Crystal River Nuclear Plant  
Docket No. 50-302  
Operating License No. DPR-72

January 31, 2012  
3F0112-11

Subject: Crystal River Unit 3 – Corrections to the Extended Power Uprate LAR #309  
Vendor Affidavit and Technical Report (TAC No. ME6527)

**REVISED PAGES OF THE CR-3 EPU TECHNICAL REPORTS**

The sequence of events for the turbine trip accident is listed in Table 2.8.5.2.1-1 and the calculated results are tabulated in Table 2.8.5.2.1-2. Figures 2.8.5.2.1-1 through 2.8.5.2.1-5 show transient plots of the significant plant parameters following a turbine trip accident.

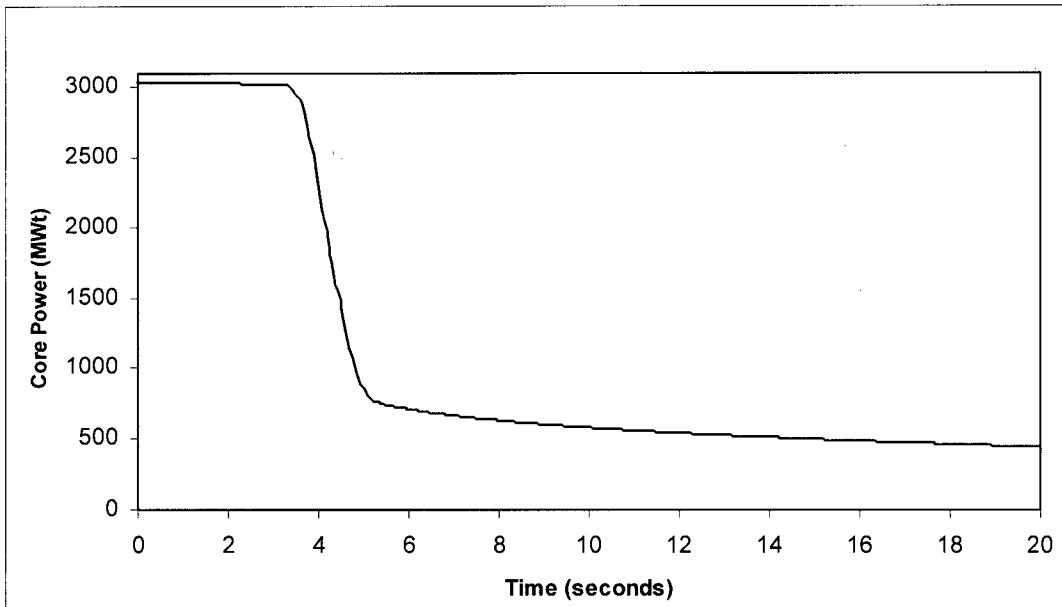
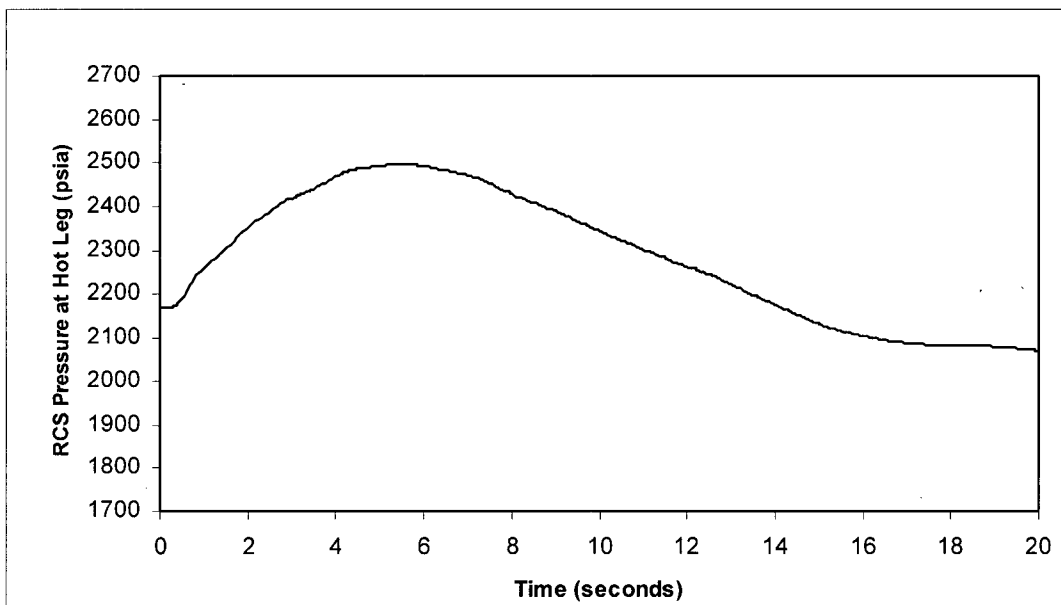
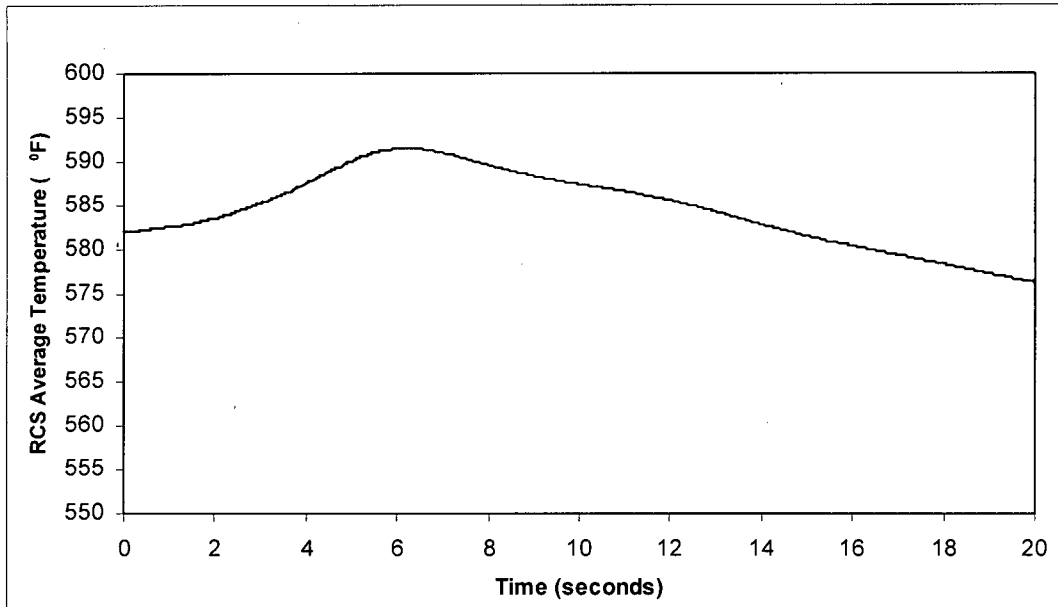
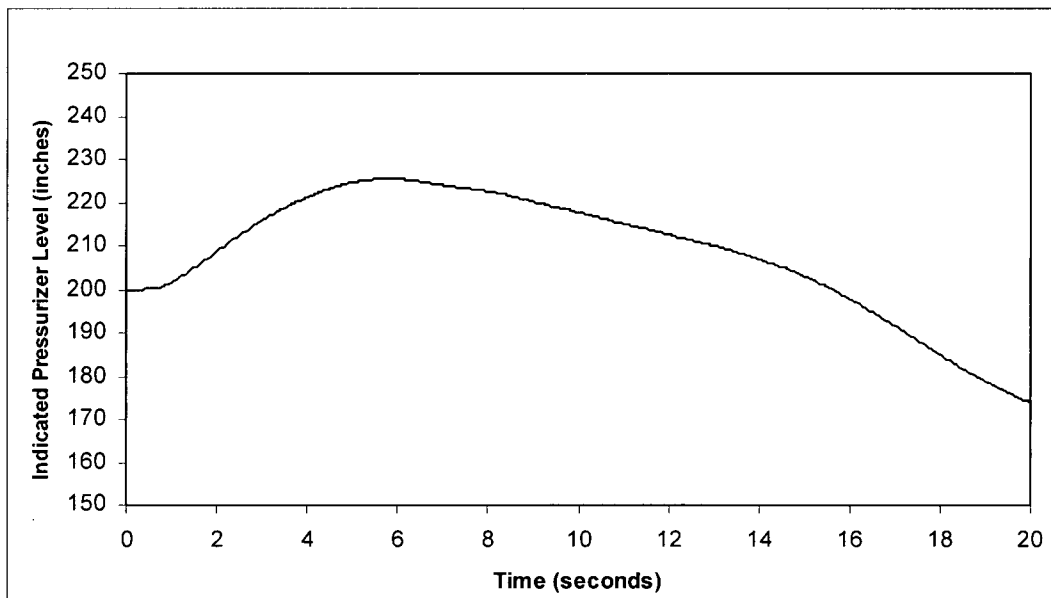
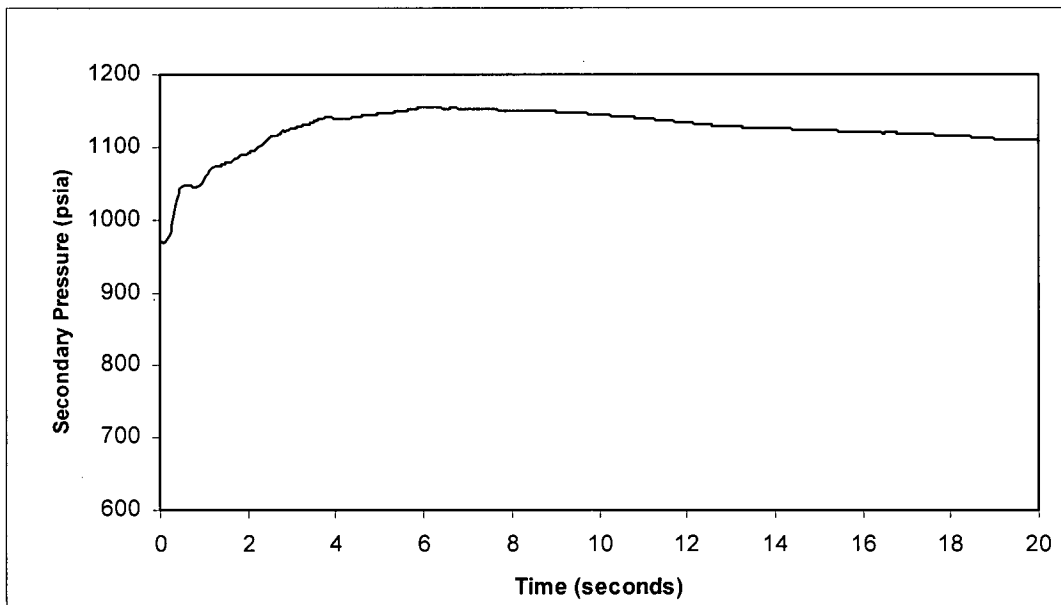
Attachment B, "Revised Pages of the CR-3 EPU Technical Report," provides a revision to the CR-3 EPU Technical Report (TR) to correct initial conditions and results of Section 2.8.5.2.1, "Loss of External Load, Turbine Trip, Loss of Condenser Vacuum, and Steam Pressure Regulatory Failure," and ancillary corrections to Table 2.8.5.0-7, "Non-LOCA EPU Analysis Limits and Analysis Results." During a vendor review of the documents supporting the CR-3 EPU TR, it was determined that the main feedwater (MFW) isolation was modeled coincident with a reactor trip. This is inconsistent with the analysis input summary document, which states that MFW isolates coincident with a turbine trip. To determine the impact of this inaccuracy, sensitivity cases have been run for the turbine trip event, assuming the MFW trip isolates coincident with a turbine trip. This does not affect the conclusion that the proposed EPU is acceptable with respect to the turbine trip event. Table 2.8.5.0-7 also includes a clarification for Note 9 to provide more specific detail regarding the acceptability of the results associated with the Locked Rotor Accident. In addition, Figures 4 through 7 of Enclosure 2, "ADV/Fast Cooldown System Modification," to Appendix E of the CR-3 EPU TR have been revised to

The RCS pressure peak was reached at 5.5 seconds and remained below the limit of 2764.7 psia. The peak steam line pressure and the peak OTSG pressure were reached at 6.0 seconds. The steam line maximum pressure was less than the corresponding limit of 1169.7 psia and the OTSG peak pressure was below the limit of 1279.7 psia.

The acceptance criteria pertaining to fuel damage and dose consequences are not challenged for this accident. This is confirmed as the power remained at or below the initial value of 3026.1 MWt, forced flow and subcooling are maintained, and RCS pressure remains within limits. The remaining acceptance criteria pertain to the RCS and secondary side (OTSG and steam line) pressures remaining below code pressure limits. From the results provided in Table 2.8.5.2.1-2, there is ample margin (i.e., more than 100 psi) between the RCS and OTSG peak pressures and their respective limits. The peak steam line pressure maintained a minimum margin of 16.7 psi. Based on these results, it can be concluded that, for a turbine trip with reactor power at the EPU conditions, the MSSVs in conjunction with the high RCS pressure reactor trip provide sufficient overpressure protection to maintain OTSG and steam line pressures below the ASME code pressure limits. Therefore, the design basis limits for fission product barriers are not exceeded or altered.

FIGURE 4: OTSB 3B – ATMOSPHERIC DUMP VALVE (CURRENT)

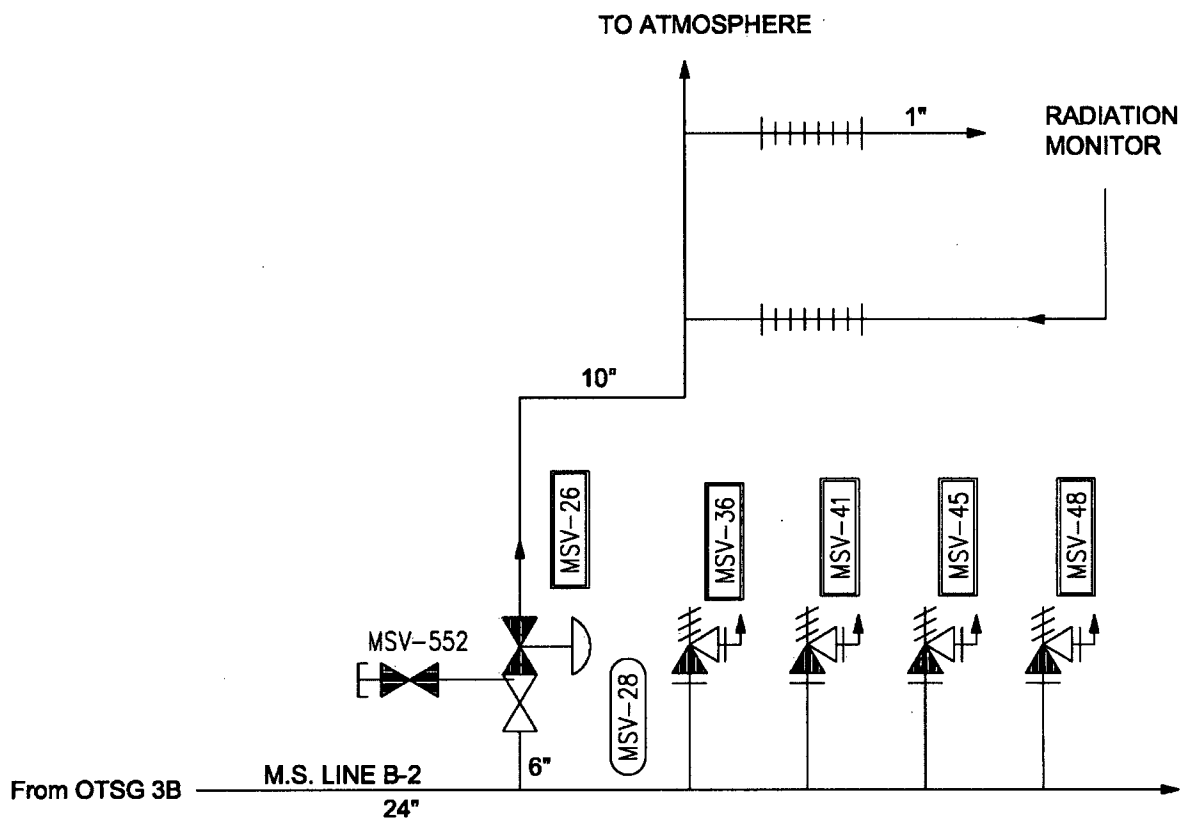
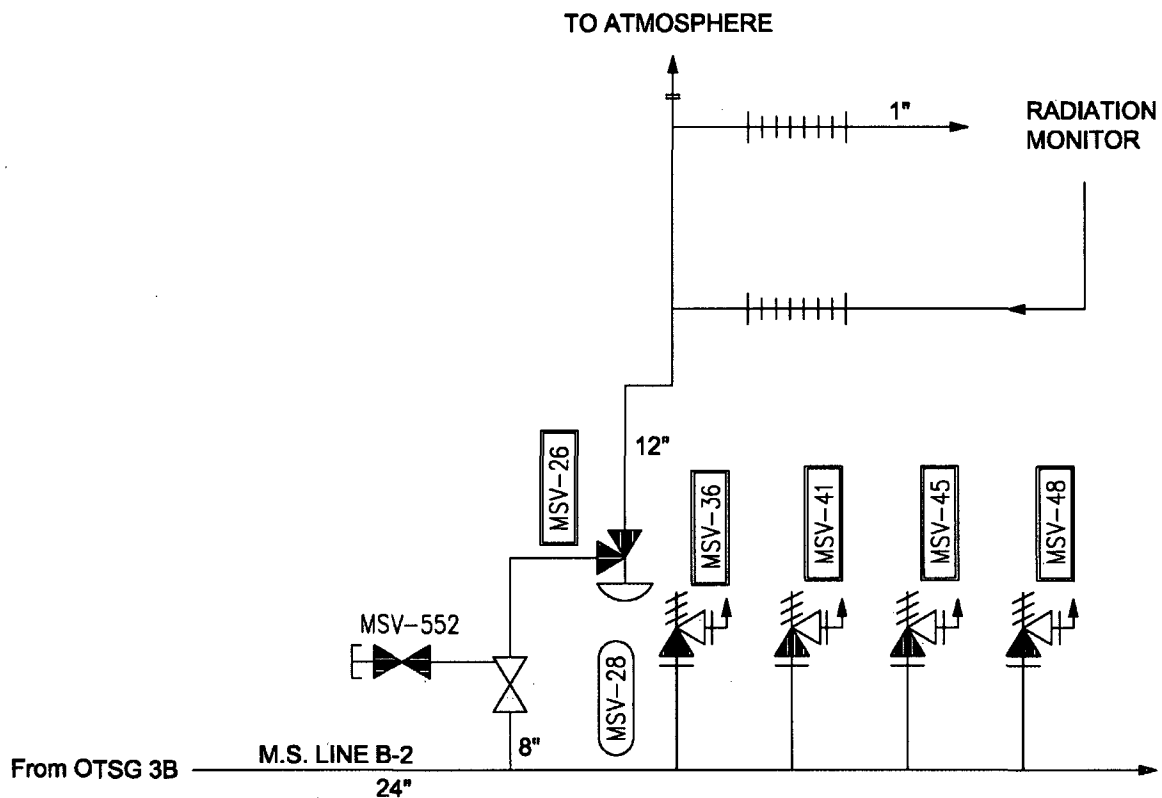
provide the correct valve numbers and lines sizes to be consistent with the related text in the enclosure and the current atmospheric dump valve (ADV) design. This administrative oversight, with the inaccurate valve and line identifications, do not adversely affect the EPU safety analyses, ADV modification design, or operational aspects of the Fast Cooldown System (FCS) or ADVs. Please remove and replace the CR-3 EPU TR pages, in copies of Attachment 5 and Attachment 7 of the CR-3 LAR #309 (Reference), with the attached revised pages.
